HISTORIC AND DESIGN REVIEW COMMISSION

HDRC CASE NO: 2022-505
ADDRESS: 515 CLUB DR
LEGAL DESCRIPTION: NCB 7070 (R MATAMOROS SUB), BLOCK 9 LOT 25
ZONING: RM-4. H
CITY COUNCIL DIST.: 7
DISTRICT: Monticello Park Historic District
APPLICANT: Gilbert Garza/Garza Design-Build LLC
OWNER: Celeste Leija
TYPE OF WORK: New construction of a 1-story, single-family residence
APPLICATION RECEIVED: November 04, 2022
60-DAY REVIEW: Not applicable due to City Council Emergency Orders
CASE MANAGER: Rachel Rettaliata

The applicant is requesting a Certificate of Appropriateness for approval to construct an approximately 2,400-square-foot 1-story, single-family residential structure.

GARZA Design*Build, LLC Is Pleased to Submit this **Responses to Comments** Historic Preservation Regarding **Mr. and Mrs. Leija Proposed New Residence** located at 515-Club Dr / Monticello Park.

A PROPOSED REVISED FRONT ELEVATION.
REFER. TO ATTACHED NOTES FOR REVISED DESCRIPTION.
MR. AND MRS. LEITA SIS CLUB DR. MONTICELLO PK.

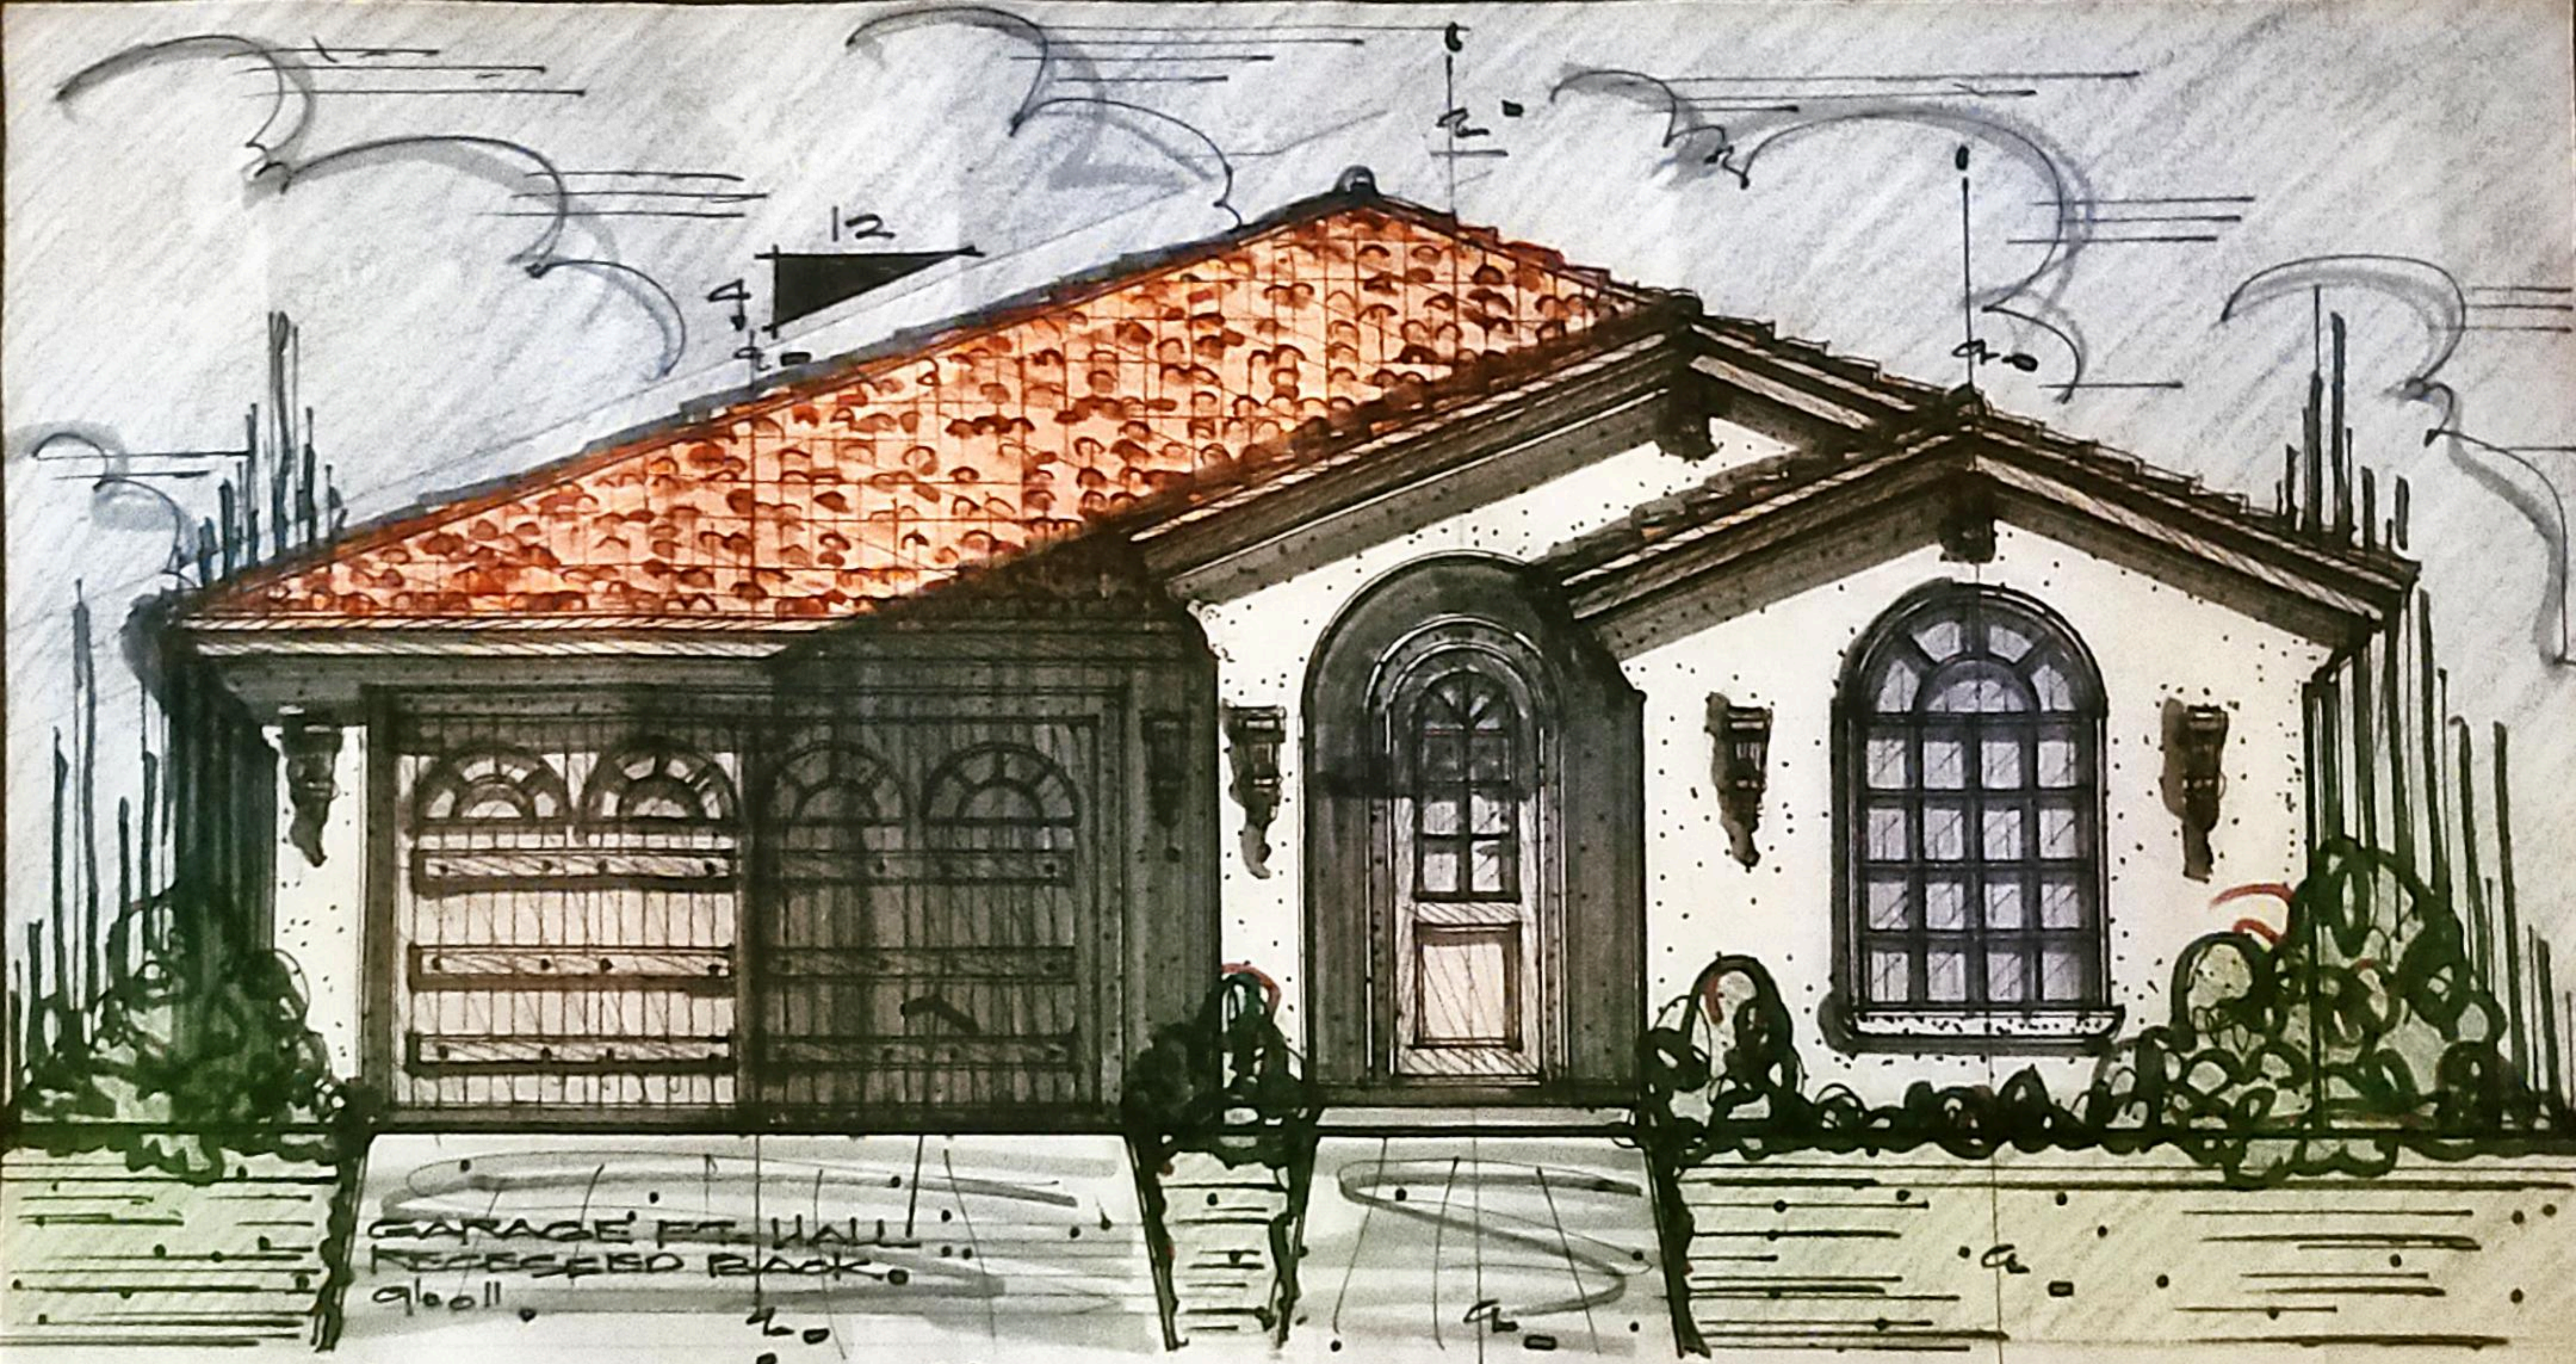
- v. That the front door arch is evaluated to be more pronounced and that the entire arch is visible and celebrated. ***This stipulation has NOT been met.***

- ii. That the applicant submits updated drawings showing the finalized front entry design, the new construction without the previously proposed chimney, and any other material and design modifications prior to returning to the HDRC based on finding k.

1. : Front Elevation is "FLIPPED" as per Floor Plan. (Front Garage Wall Recessed 9'-0" back.)
2. : Roof Pitch is Lowered from 8 / 12 pitch to 4 / 12 Pitch.
3. : Front Entry Porch Flat Parapet Roof is Deleted and replaced with Gable Roof.
4. : Front Bedroom #02 Window is reduced from 6'-0" wide to 5'-0" wide.
5. : 02 - Side decorative wing wall are deleted.
6. : All, Stucco banding has been deleted to minimum only.
7. : Small Shed roof over 02-Car Garage door has been deleted.
 - Refer, to Attached Proposed Front Elevation Plan Drawing for additional Information.

MR. AND MRS. LEIJA • SIS • CLUB DR • MONTICELLO PARK •
 PROPOSED • WINDOWS W/ 3" REVEAL DETAIL •
 • EXHIBIT • TIA • VI

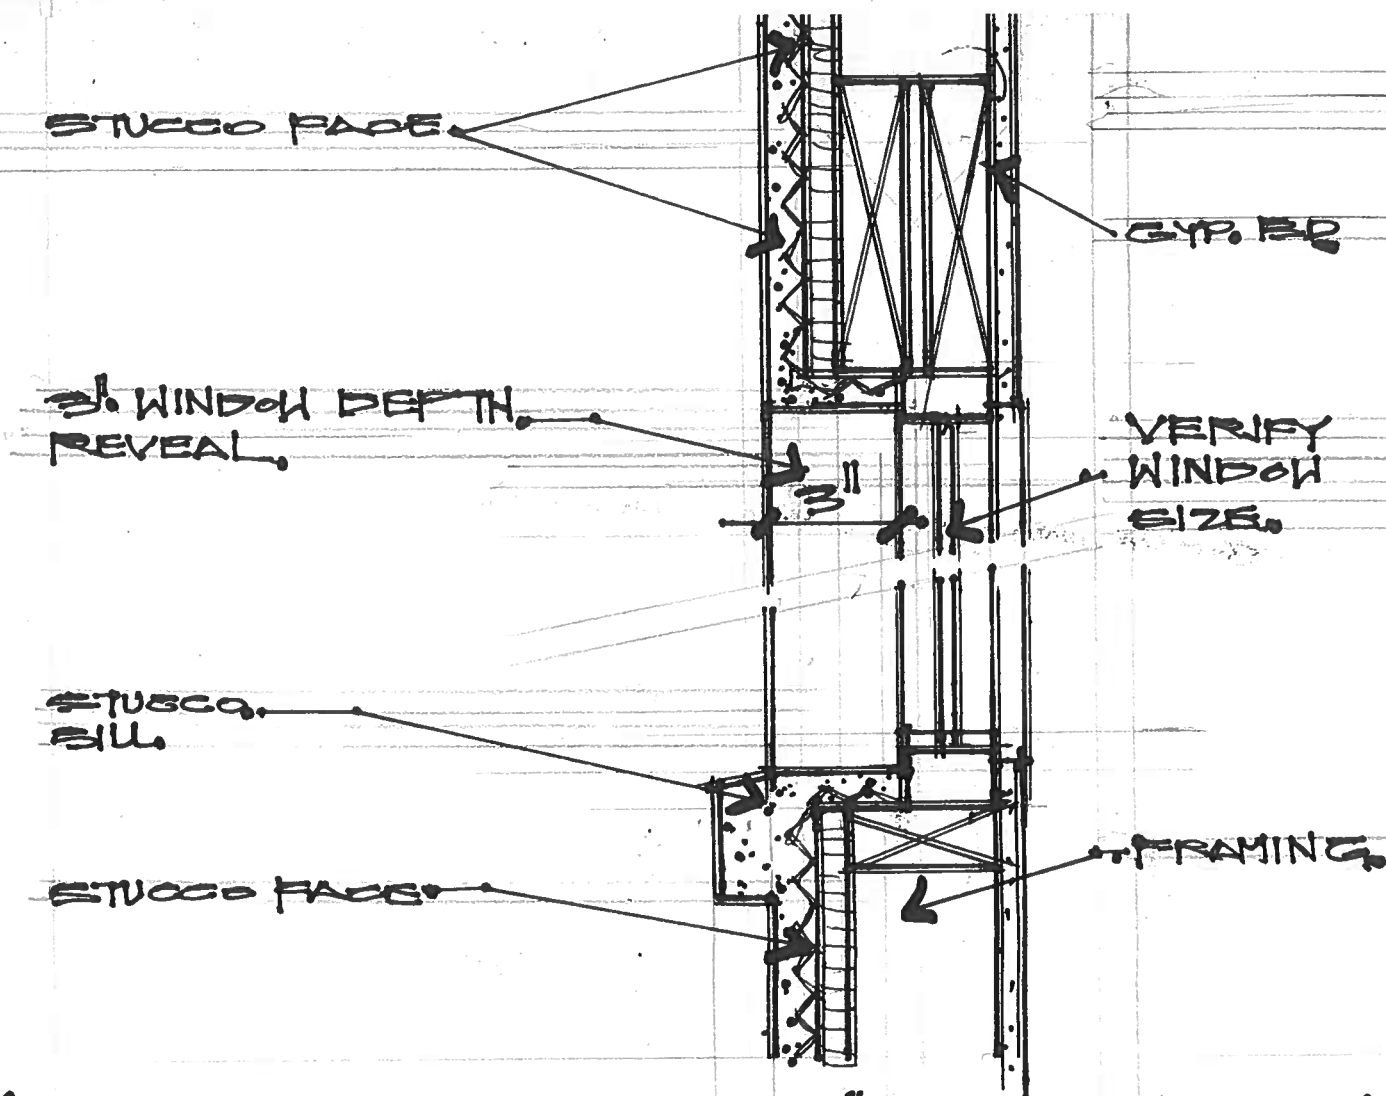
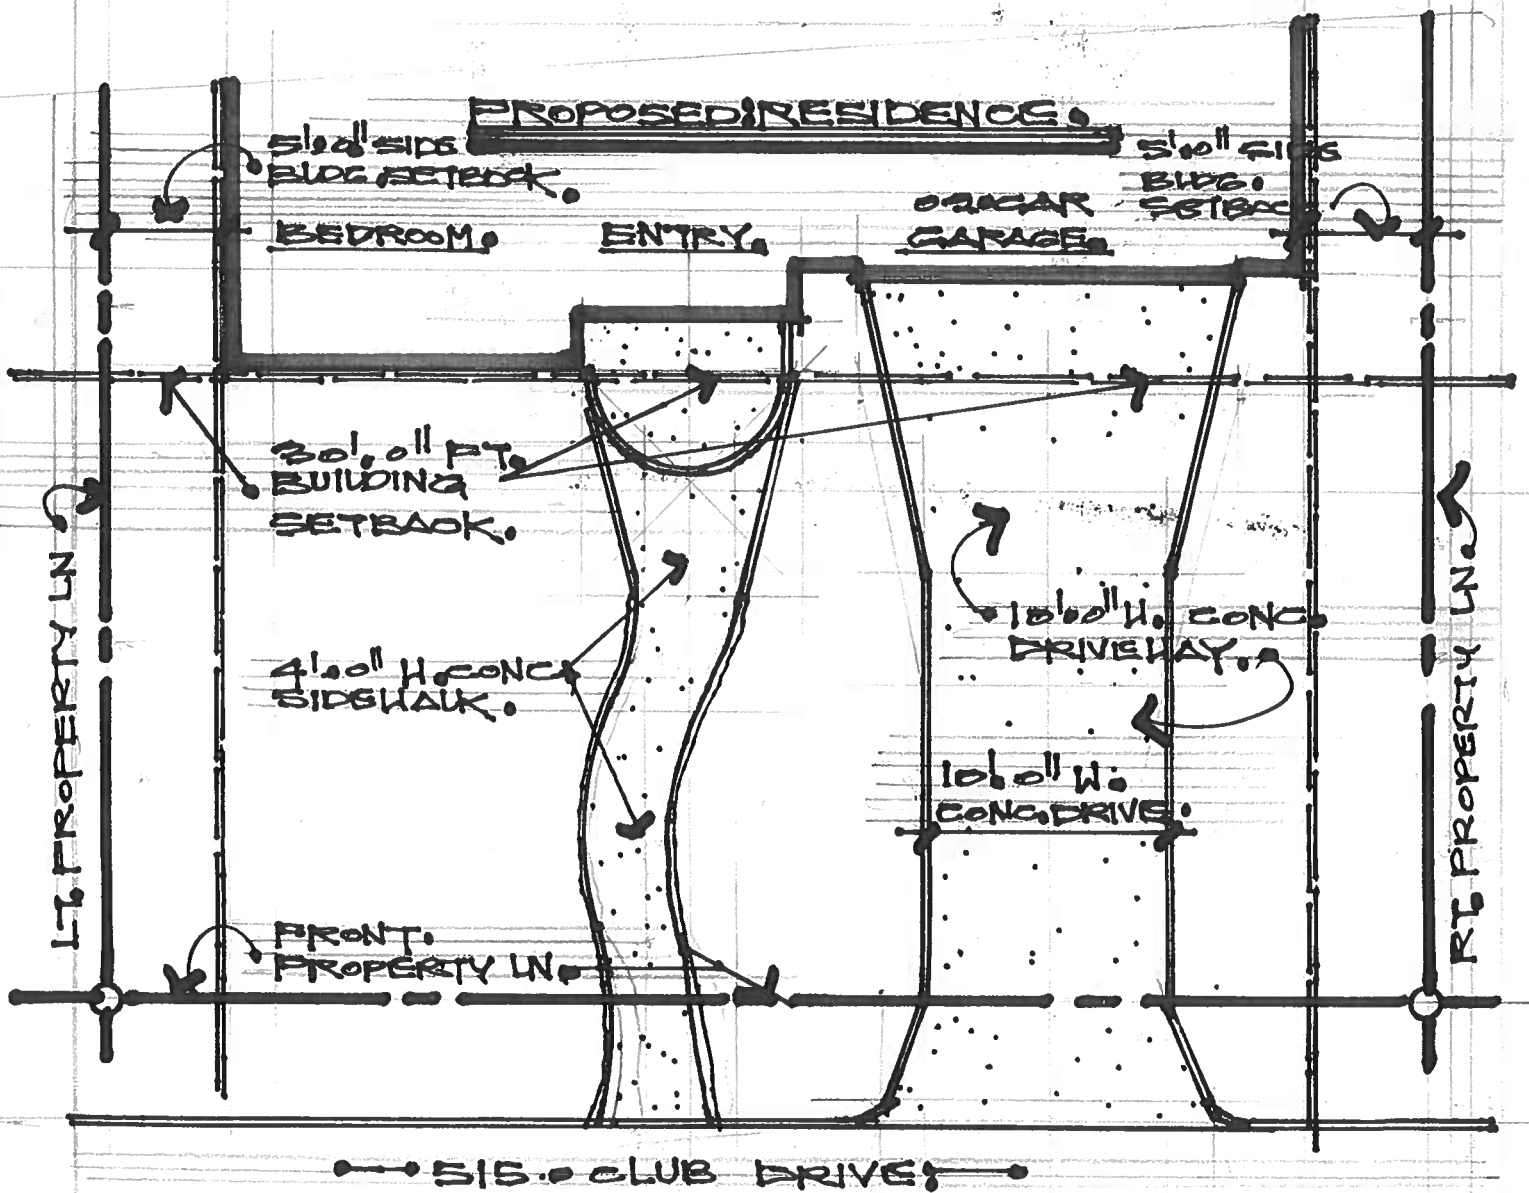
- ii. That the applicant submits window specifications to staff for review prior to returning to the HDRC based on finding i. Wood or aluminum-clad wood windows are recommended. Windows should feature traditional operations, an inset of two (2) inches within facades, and profiles that are found historically within the immediate vicinity. White manufacturer's color is not allowed, and color selection must be presented to staff. There should be a minimum of two inches in depth between the front face of the window trim and the front face of the top window sash. This must be accomplished by recessing the window sufficiently within the opening or with the installation of additional window trim to add thickness. Window trim must feature traditional dimensions and architecturally appropriate sill detail. Window track components must be painted to match the window trim or concealed by a wood window screen set within the opening. ***This stipulation has been met, although the stipulation remains through final approval.***

- VI : Submit all Proposed Window Materials Specs, Window Style, 2" recess Window detail and Windows location
 - * R. : **Window specs and style provided in previous meeting. (Article previously submitted.)**

01. REFER TO ARCHITECTURAL PLANS FOR ALL WINDOW SIZES, STYLES AND LOCATIONS.
02. WINDOWS TO BE ALUM. • BLACK FRAME, DEL. INSULATED. LOW E" WINDOWS W/ SCREEN.

PROPOSED: FRONT LANDSCAPING LAYOUT PL

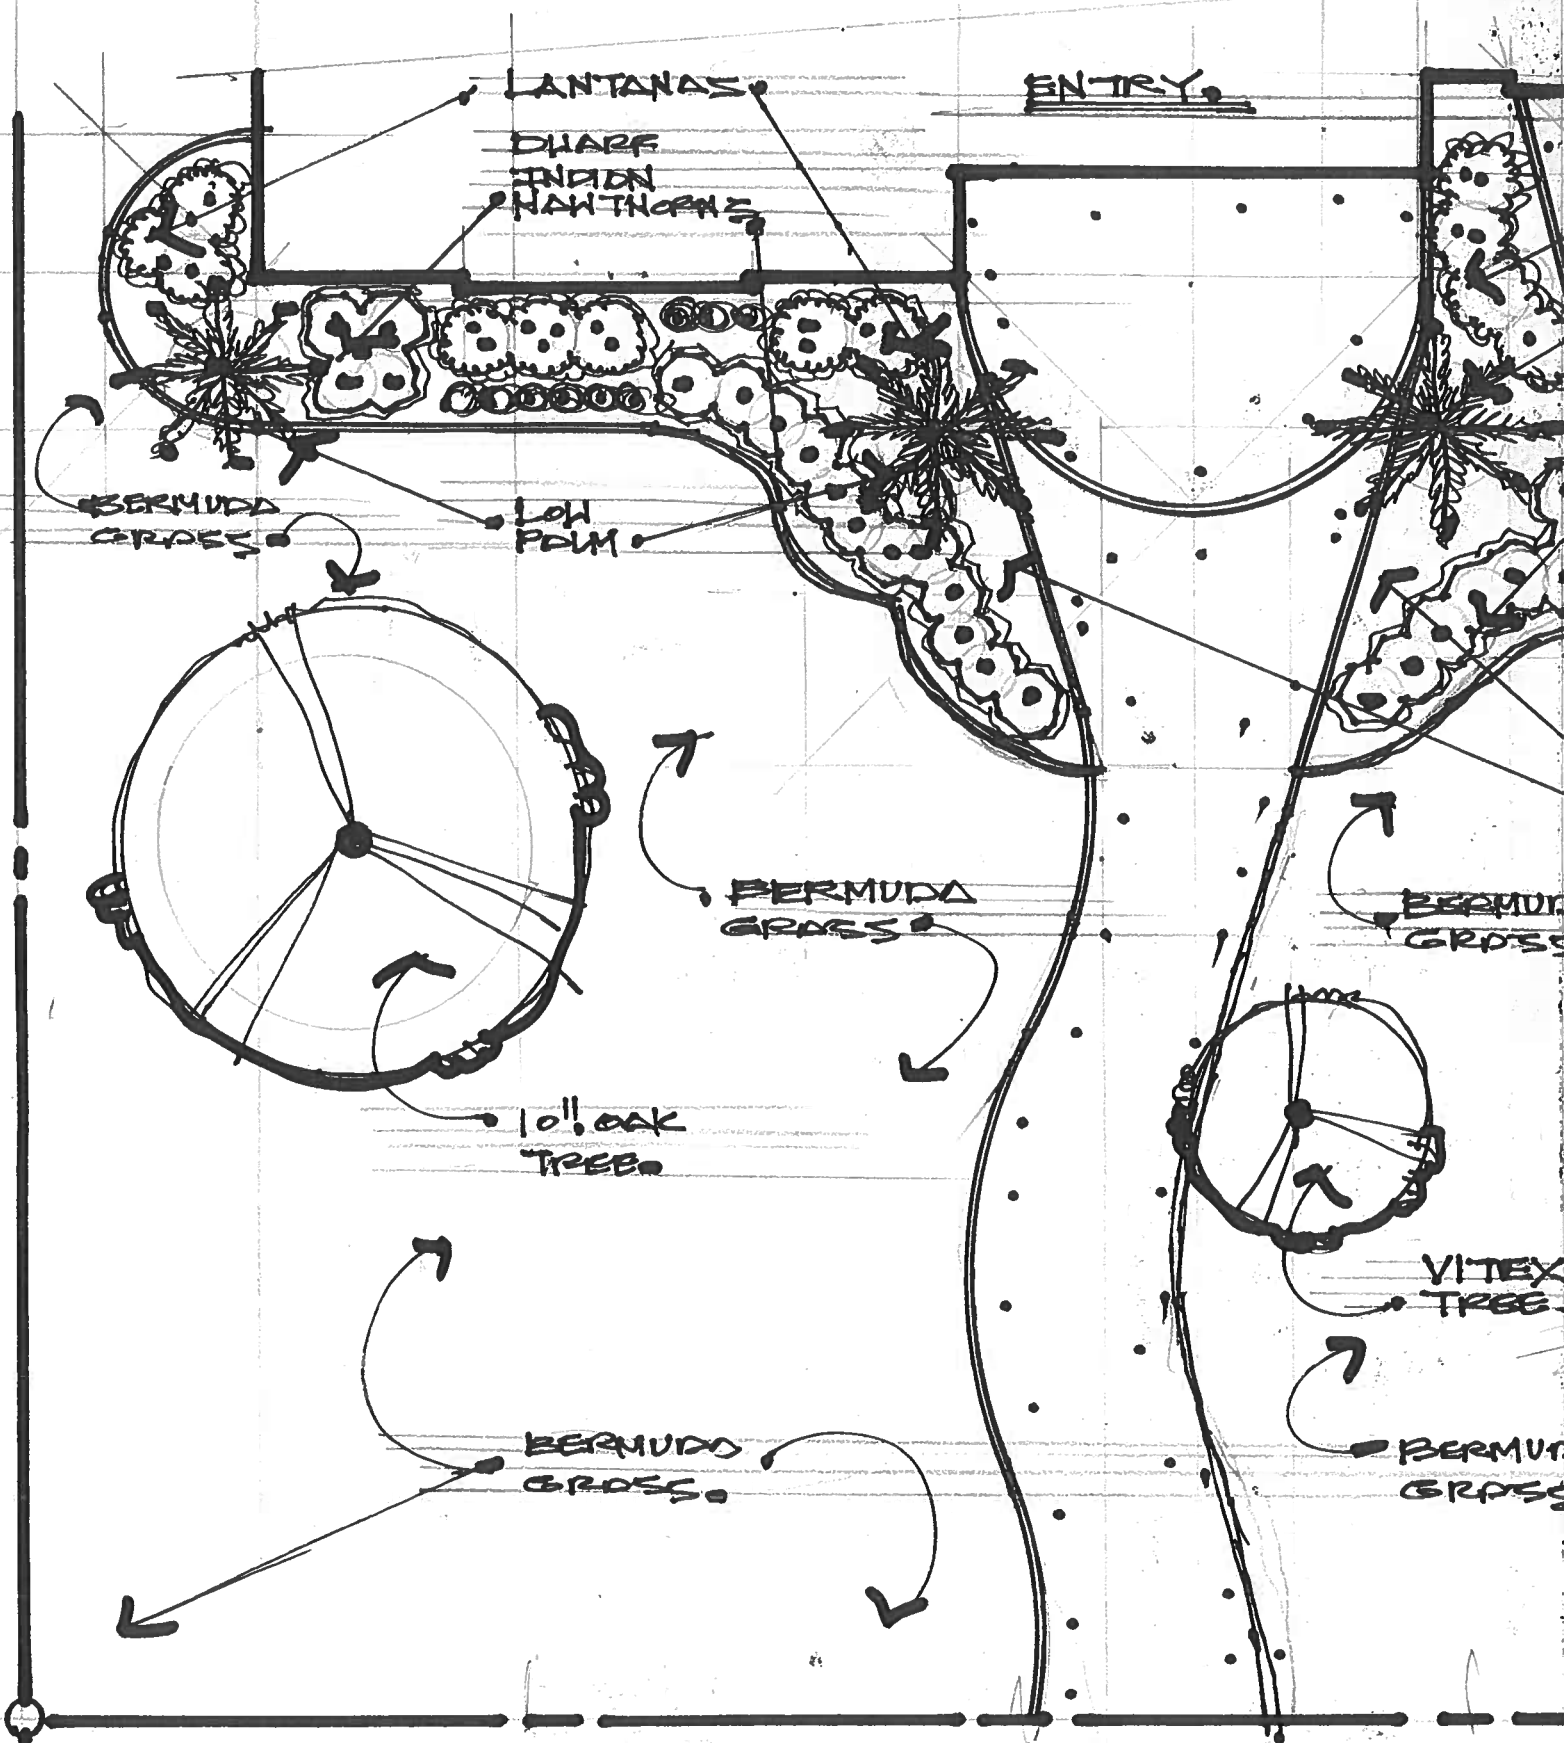
HDRC for final approval as noted in finding p. ***This stipulation has NOT been met. A landscaping plan for the front yard as been submitted for review.***

- XI : Submit a Final Proposed Landscaping Plan with Planting details and a Proposal to Re-Use existing Stone mats
 - * R. : **Previously submitted. (Article previously submitted.)**
